**Re: Floodplain Variance (FPV) #21-002  
FPDP# 2021142 (Denied) - Culebra Creek Channel Improvements  
Public Works Department Capital Improvement Project (WBS# 23-03730)**

| <b>Project Name:</b>        | Culebra Creek Channel Improvements (Timber Path to Old Grissom Rd) |

Re: Culebra Creek Channel Improvements (Timber Path to Old Grissom Rd)  
WBS #23-03730  
UDC Codes 35-F124(c) and 35-F133(c)(2-3)

Figure 2. Example Structure WSE Comparison

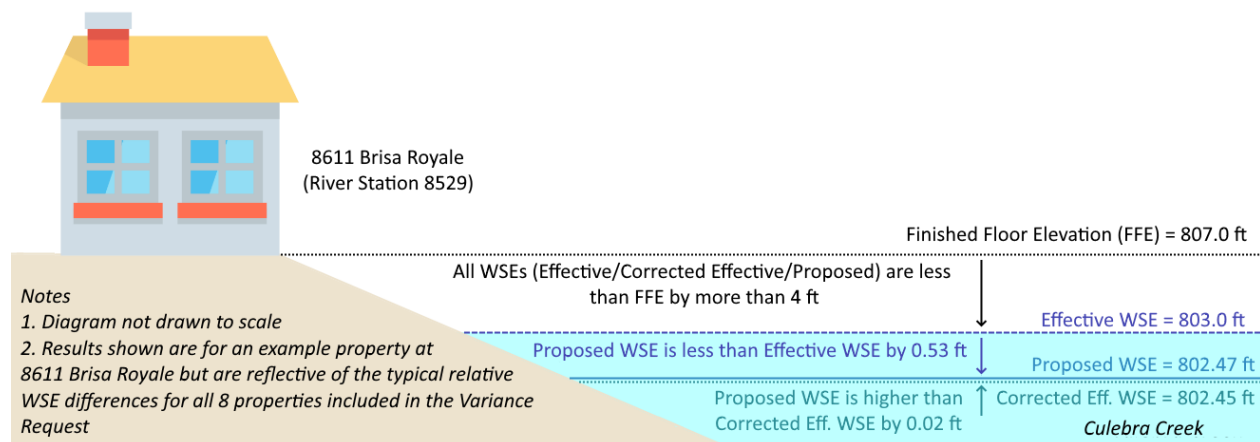
- The slight WSE increases mentioned above are reflected only in a comparison of the 'Proposed' and 'Corrected Effective' hydraulic modeling scenarios. Even when these slight increases are factored in, the proposed water surface elevations are between two (2) and five (5) feet lower than the adjacent structures' finished floor elevations. Reference Figure 2 in the engineer's variance request letter.

- A comparison of the 'Proposed' and 'Effective FEMA' hydraulic modeling scenarios and resulting water surface elevations shows that the proposed water surface elevations are expected to be lower than the current Effective water surface elevations, thereby expecting to provide a reduction in flood insurance requirements, even outside of the project limits, following project construction and remapping. Reference Figure 2 in the engineer's variance request letter.
